Access Compliance Report Public Rights-of-Way (Curb Ramps)

Main Street: N_LINDA_VISTA_ST Cross Street: VILLA_PARK_RD Location: SW

ADA ID: RPRK211222121407 Ramp Type: Type 1 - Perpendicular Diagonal Initial Pass/Fail: Fail Overall Compliance: No Severity Score: 16

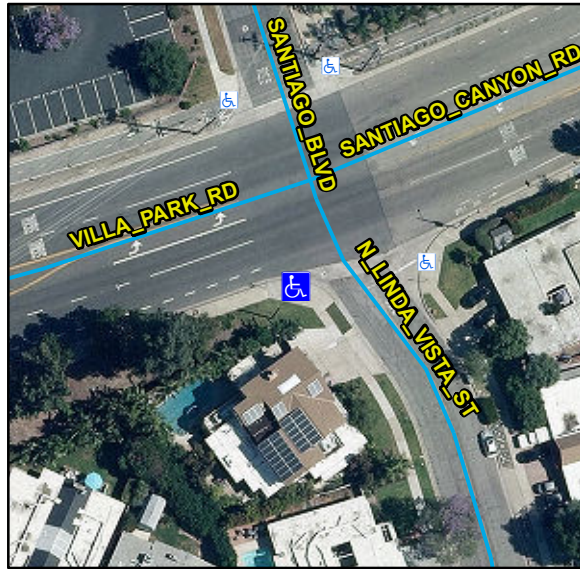
R304.2.2, R304.5.3, R302.7.2, STD 1115

Remove & Replace Curb Ramp With Two New Directional Ramps or Equivalent. Grind Gutter Lip.
